SUBJECT: Gerrish Drive/Ambler Way Subdivision - Comments regarding Private Access Road - Durham Public Works

This memorandum has been prepared in advance of the May 12th Planning Board meeting and is intended to further substantiate Town staff's recommendation that, in the event the Gerrish/Ambler subdivision receives approval, the access road shown on the plan dated April 20, 2021, and extending from station 0+00 to 5+00, leading to the Gerrish/Ambler "loop road", remain a Private roadway upon completion, rather than a publicly accepted road.

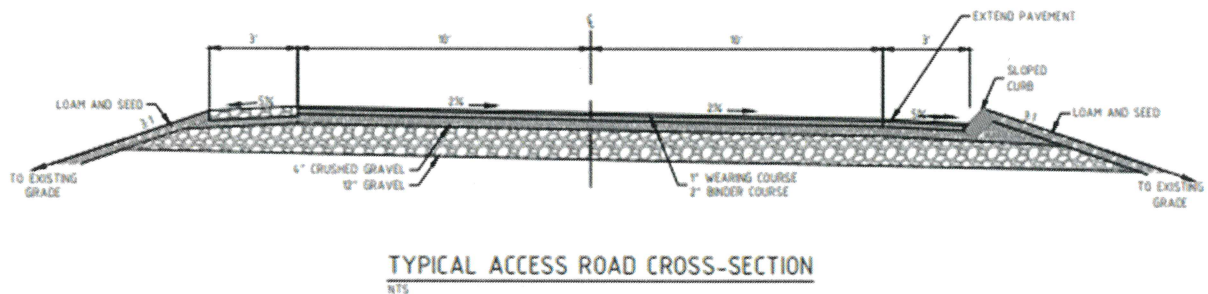
It is essential to recognize the pavement and shoulder width represent only two of the critical components of the overall roadway and are not the only factors in the Town's roadway standard design. Many other components are reviewed including side slopes, fill slopes, guardrails, utility layout, gutter width, etc. For example, in accordance with the Town standard, as detailed in the Road Construction Regulations adopted by the Planning Board, *"Embankment slopes away from the edge of the finished roadway shall not be constructed at a ratio steeper than 4' horizontal to 1' vertical unless the length of the grade is greater than 10'. If the horizontal length of the grade exceeds 10', a ratio of 3' horizontal to 1' vertical may be used. W beam guard rail may be required by the Dept. of Public Works."* Approximately 135 lineal feet of roadway, located between the two wetland

crossing areas has been designed in general conformance with the standard. A detail is shown below for your reference. Please note the 3:1 fill slope and lack of retaining walls in this limited section.

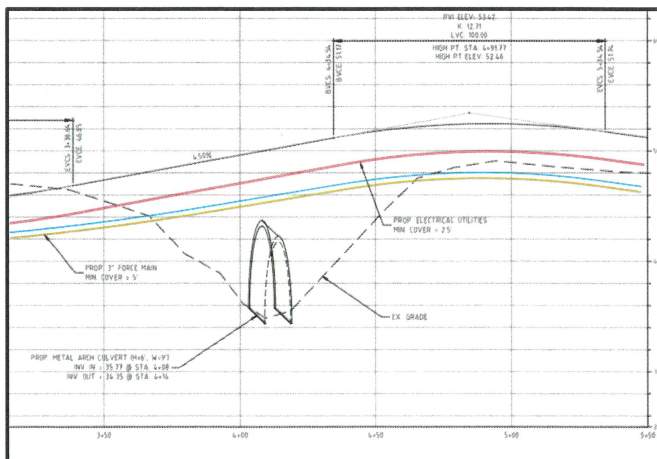
It is also worth noting the current plan and utility corridors only identify water, sewer and one UGU (Underground Utility) within the access road. The UGU likely will include underground electric and a minimum of one telecommunications line, each with their own separation requirements and required utility corridor which will occupy a larger ROW footprint. The additional two feet of roadway width and gutter width could prove to be beneficial to accommodate other appurtenances such as transformers, vaults and associated structures. This becomes even more critical if a closed drainage system is used which may be required on a public roadway, following additional analysis as noted below.

The second wetland crossing is substantially larger and more concerning where a metal arch pipe is utilized to carry the roadway over an existing stream. The metal arch pipe is sized as 6' high by 9' wide with over 200 feet of precast retaining wall reaching heights of approximately 16 feet. The consensus, following durability studies conducted by many State Highway Departments is, a corrugated steel pipe has a life expectancy of 35 years before perforation of metal occurs. Coatings can be applied but their performance is marginal, adding maybe an additional 5 years to the expected life. A snip of the profile view of this crossing is shown below for you reference which illustrates the type of structure and wall height.

The Town of Durham presently has a large metal arch pipe similar to the one being proposed which carries Mill Road over the Oyster River. Following a recent NHDOT bridge inspection, it was found that the metal pipe was exhibiting moderate rusting, pitting and scaling with scattered perforations and 25% section loss. The stone headwall and wing walls have settled and failed downstream. The bridge was added to the Municipal Red List and will require either, an interim repair or full replacement at significant cost, likely exceeding \$450,000. In the event the access road was ever to be considered for public roadway acceptance, Durham Public Works would require a concrete box culvert with a natural bottom and the use of precast wing walls to substantially decrease the use of precast blocks and increase the longevity of the structure.
